UNITED STATES PATENT AND TRADEMARK OFFICE

APPLICATION NO.	FILING DATE	FIRST NAMED INVENTOR	ATTORNEY DOCKET NO.	CONFIRMATION NO.
09/801,409	03/08/2001	Gajender Rohilla	CD 00-214	2883
20575	7590	03/17/2005	EXAMINER	
MARGER JOHNSON & MCCOLLOM, P.C. 1030 SW MORRISON STREET PORTLAND, OR 97205			RODRIGUEZ, ARMANDO	
			ART UNIT	PAPER NUMBER
			2828

Office Action Summary

DETAILED ACTION

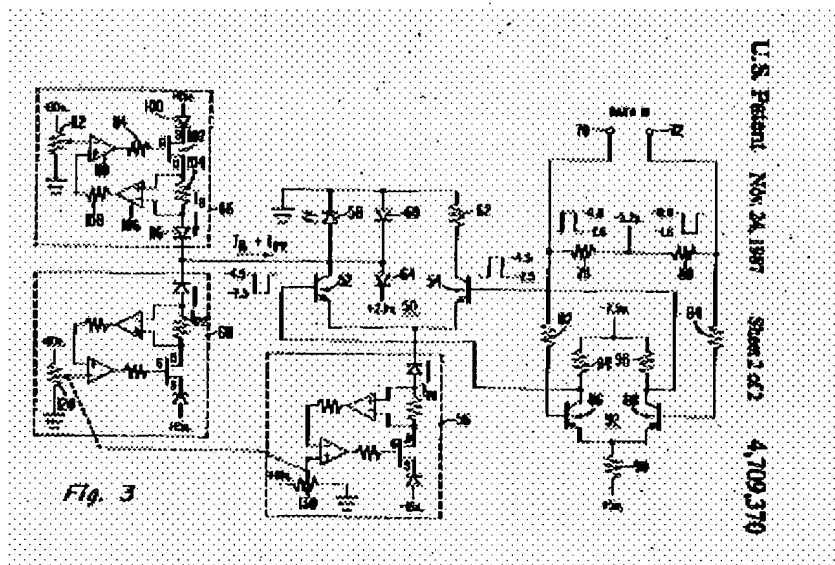
After carefully reviewing applicant's arguments on pages 6 and 7 and further reviewing the cited prior art of Bednarz et al (PN 4,709,370), the examiner finds that applicant does not describe a third current in the specifications and does not illustrate a third current in the drawings. Applicant's specification only describes two current sources, where a first current source includes an I_{mod} and the second current source includes $I_{mod} + I_{bias}$; as understood by the examiner when the first transistor is ON the laser receives $I_{mod} + I_{bias}$ and when the second transistor is ON the laser receives I_{bias} , which is the exact operation of the cited prior art in figure 3 as described in column 5 lines 9-35.

The examiner will interpret the cited reference to Bednarz as the combination of current sources (66) and (68) as applicant's second current source because the combination of (66) and (68) provide I_{bias} for biasing the laser and I_{p2} a pulse current (modulation).

Figure 3 illustrates a circuit having two transistors (52) [applicant's first transistor] and (54) [applicant's second transistor], where the transistors each receive an input

signal [applicant's two inputs], a constant current source (56) [applicant's first current source], which is connected to both transistors (52) and (54), constant current sources (68) and (66) [applicant's second current source], which is connected to transistor (52) and I_{bias} for biasing the laser and I_{p2} a pulse current, as described in column 3 line 53 to column 4 line 3 and column 5 lines 9-35. Column 3 line 67 to column 4 line 1 and column 5 lines 42-43, describes the constant current sources (56) and (68) as substantially equal. As illustrated in figure 3 and described in column 5 line 9-35, current source (56) provides a first current, current sources (66) and (68) provides a second current, when transistor (52) is fully conducting the laser draws I_{bias} and when transistor (54) is fully conducting the laser draws $I_{bias} + I_{p2}$, where I_{p1} and I_{p2} are substantially equal. Thereby, when transistor (52) the laser receives I_{bias} [applicant's third current].

Figure 3 illustrates the use of Bipolar transistors, as described in column 3 lines 53-57 as NPN transistors.

Figure 3 illustrates the inputs connected to the base of the transistors (52) and (54), as described in column 4 lines 40-42.

Figure 3 illustrates current source (56) connected to the common emitters of the transistors (52) and (54), as described in column 4 lines 1-3.

Figure 3 illustrates current source (68) connected to the collector of transistor (52).

Figure 3 illustrates a semiconductor laser diode (58), as described column 3 line 61.

Figure 3 illustrates the laser diode connected to the collector of transistor (52).
